2 Fuel and ignition system

911 GT3 RS

The following describes the modifications of the 911 GT3 RS compared with the 911 GT3 model year 2004.

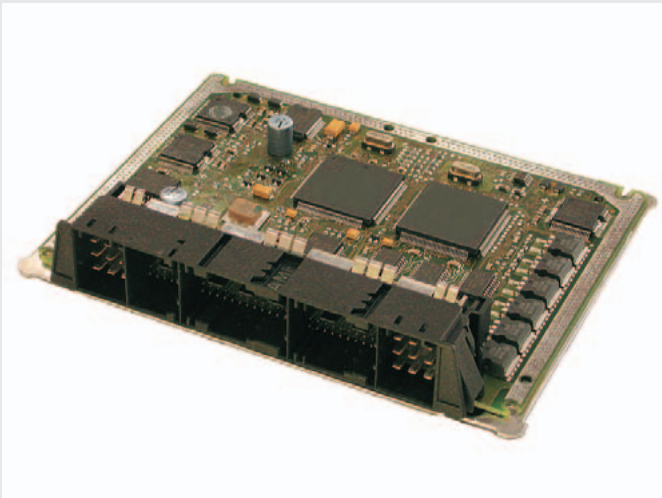
The 911 GT3 RS has modified air ducting of intake air from the rear lid to the air cleaner. A RAM air inlet on the rear lid improves engine induction at higher speeds through ram induction.
